In the Matter of)	
)	Docket 50-344
PORTLAND GENERAL ELECTRIC COMPANY,)	
et al)	(Control Building Proceeding)
)	
(Trojan Nuclear Plant))

I hereby certify that on July 10, 1979, Licensee's letter to the Director of Nuclear Reactor Regulation dated July 10, 1979 and an attachment entitled "Request for Additional Information, Trojan Nuclear Plant, Proposed Control Building Design", have been served upon the persons listed below by depositing copies thereof in the United States mail with proper postage affixed for first class mail.

Trojan Nuclear Plant
Docket 50-344
License NPF-1

Enclosed are the answers prepared by Bechtel Power Corporation to the remaining five questions from your letter of May 18, 1979. This submittal answers the last of the formal questions posed by your staff. A revision to PGE-1020 covering updated information will be issued shortly.

Figure 46-7 Secant Modulus, Specimen B-2

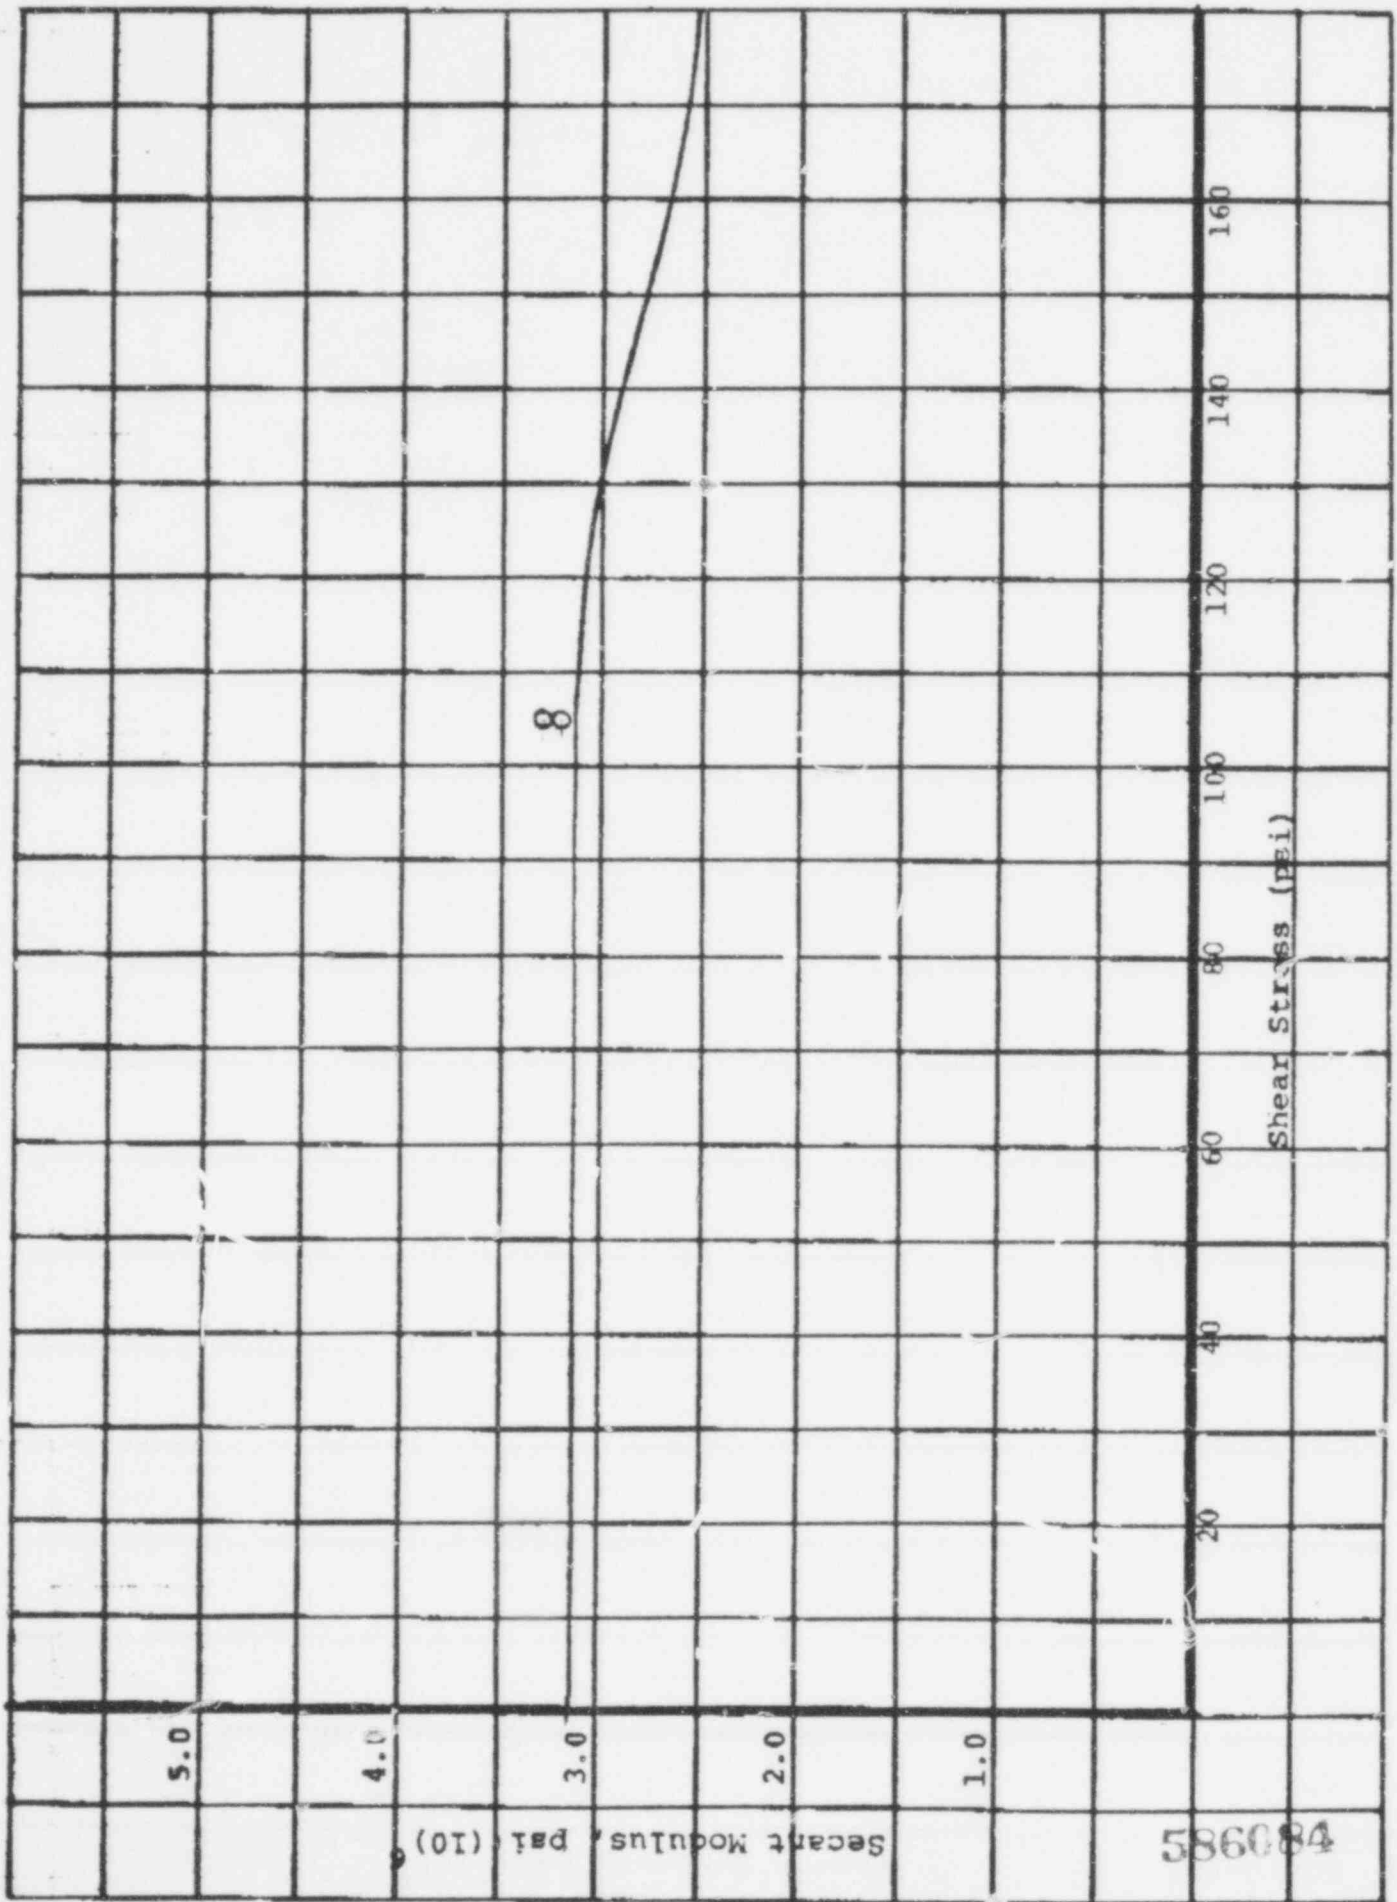
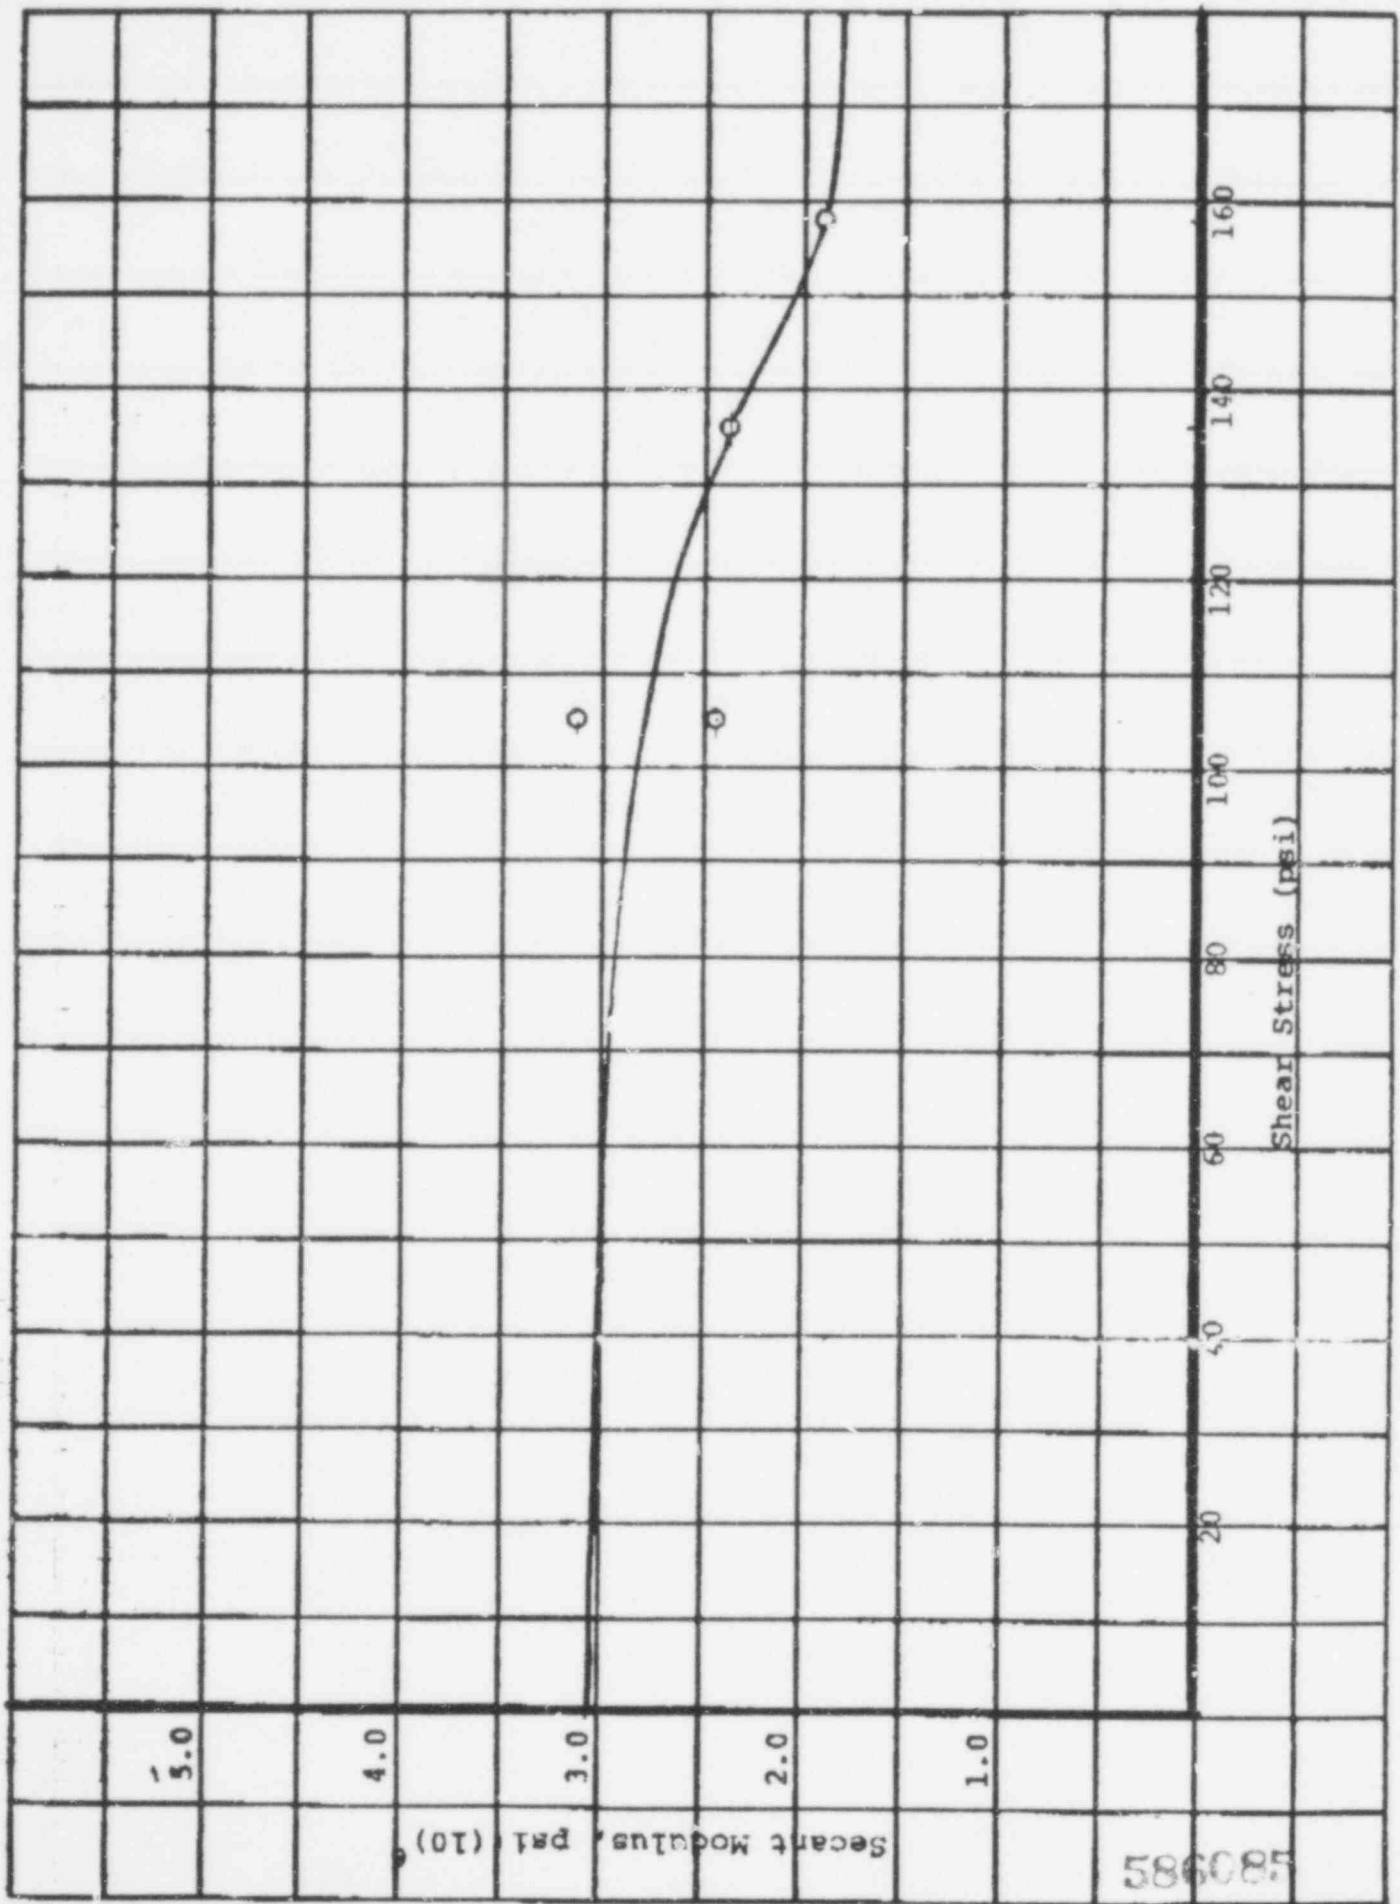
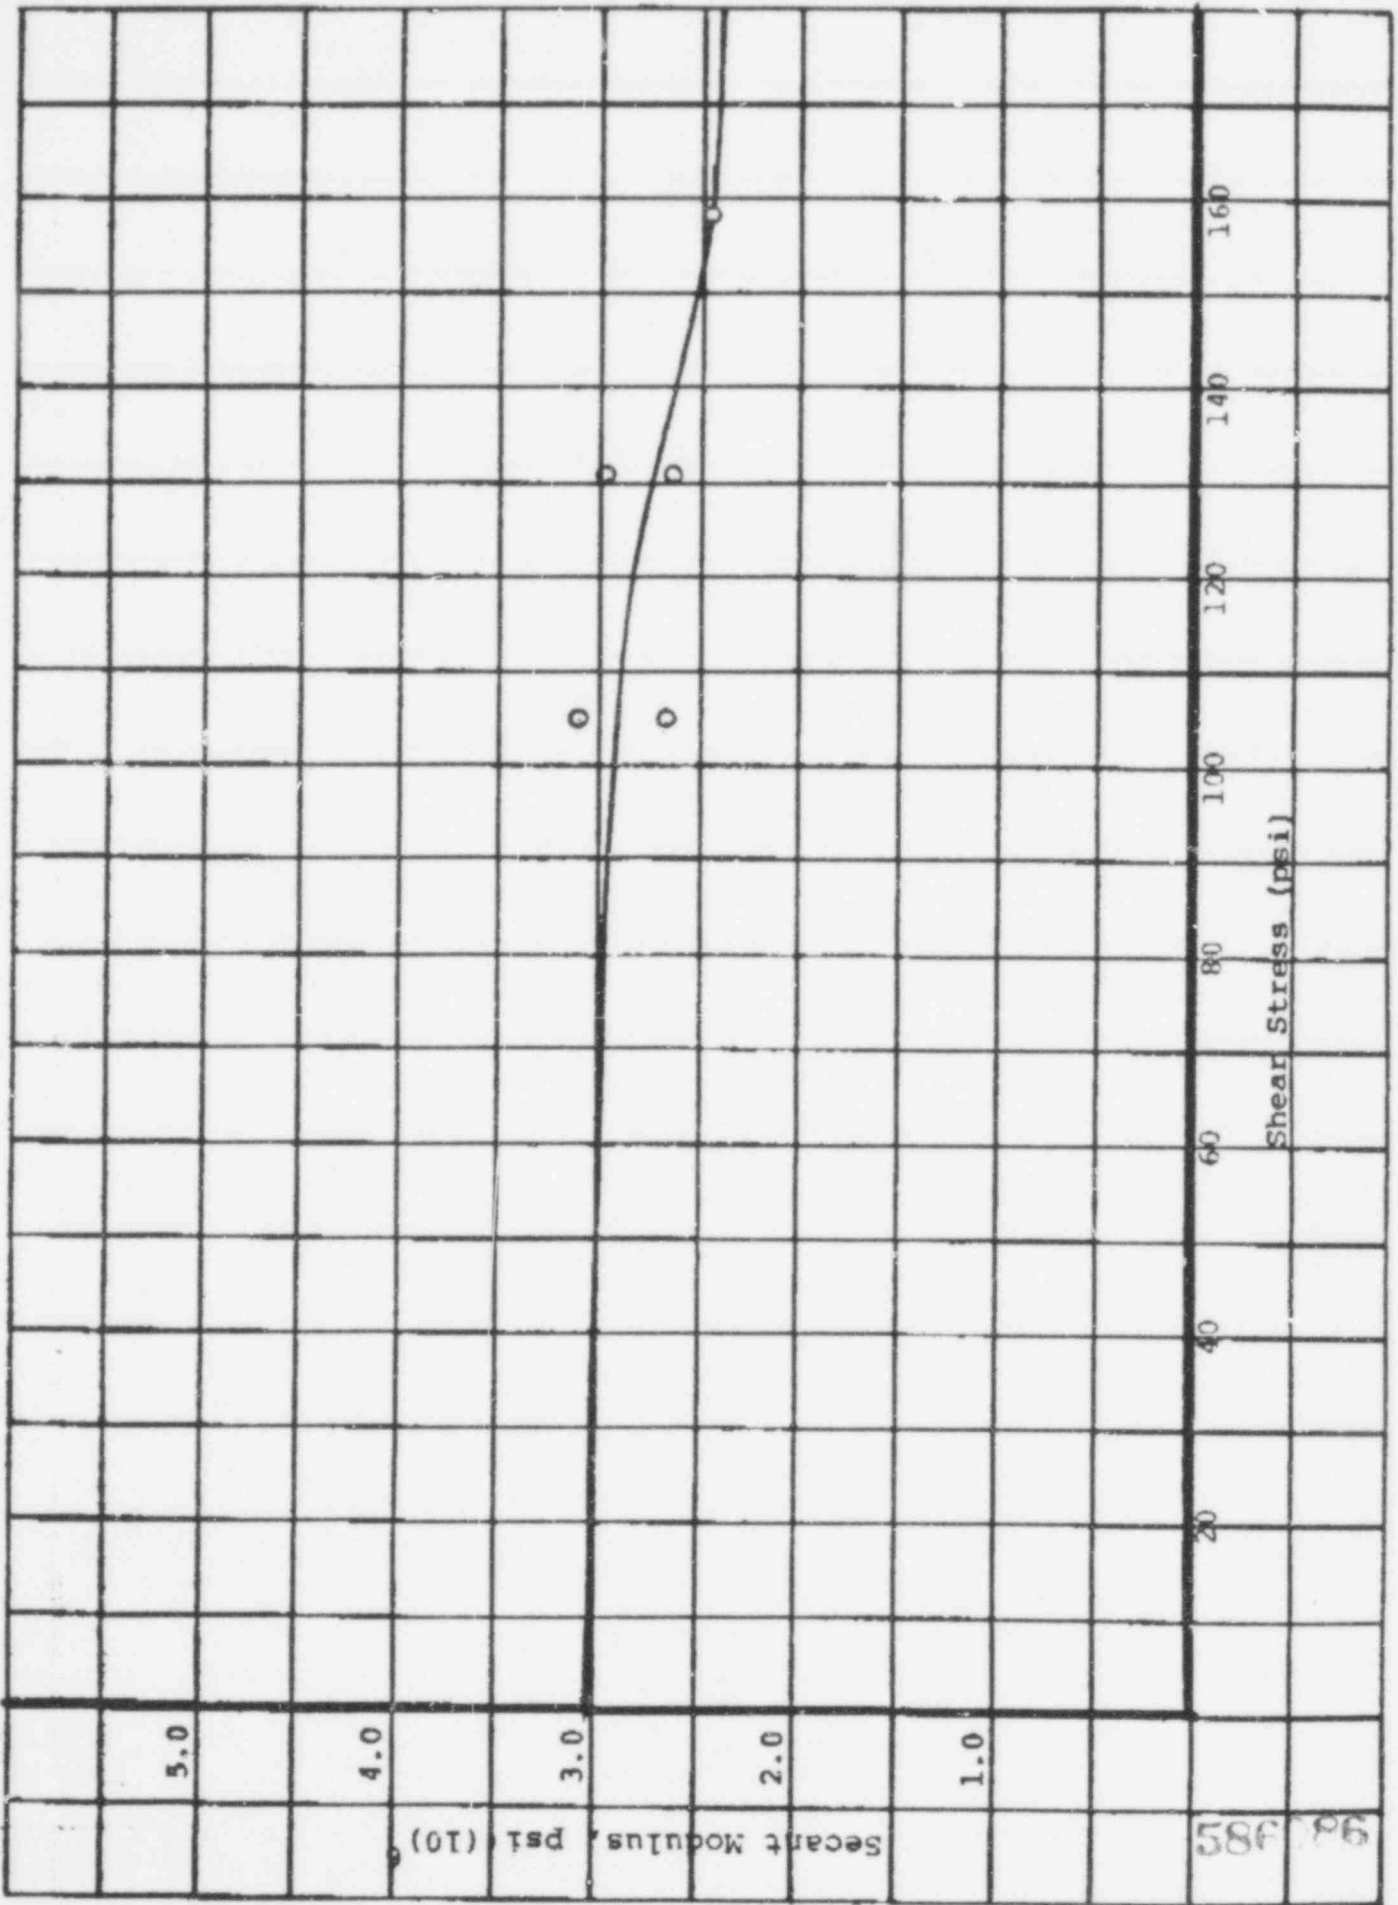
Provide the secant modulus derived for each of the test specimens vs. stress level; a comparison of the experimental initial elastic modulus for the test specimens vs. that calculated using the formula in Section 2.2.1.3.2 of Appendix B; the error bands, and their deviation, for the curves representing stiffness reduction as a function of stress level; and the stresses in each of the walls resulting from incorporation of the stiffness reduction factors in the STARDYNE model along with the associated stiffness reduction factors assumed in the analysis.

The secant modulus vs. shear stress for the test specimens is shown in Figures 46-1 through 46-20. A comparison between the experimental initial elastic modulus and that calculated using the formula in Section 2.2.1.3.2 of PGE-1020, Appendix B cannot be made since the initial modulus cannot be determined experimentally. The instrumentation was not sufficiently sensitive to measure the small deflections required for the calculation. Deflections need to be measured reliably to the nearest .0002 inch at the early stages of deformation. During this stage, the test specimen and load frame is settling in, play in instrumentation is being taken up, etc. Care was taken to minimize these effects but all could not be completely eliminated since the movements being considered are between 1 and 10 times smaller than the thickness of this paper. Some difficulty was even encountered at the first load step but for the other load steps the deflections were

large enough so that effects were not important. As shown in Figures 46-1 to 46-20, there are in general two data points at the first load step. The top part is obtained from the average deflections recorded on each side of the specimen and the other is obtained from the most active dial gauge. The initial modulus used in the plot was calculated using the equation in PGE-1020, Appendix B. An error analysis of the data could not be made since there are not enough specimens with duplicate conditions to provide sufficient data base. The effect of variation is considered in the broadening of the response spectra.
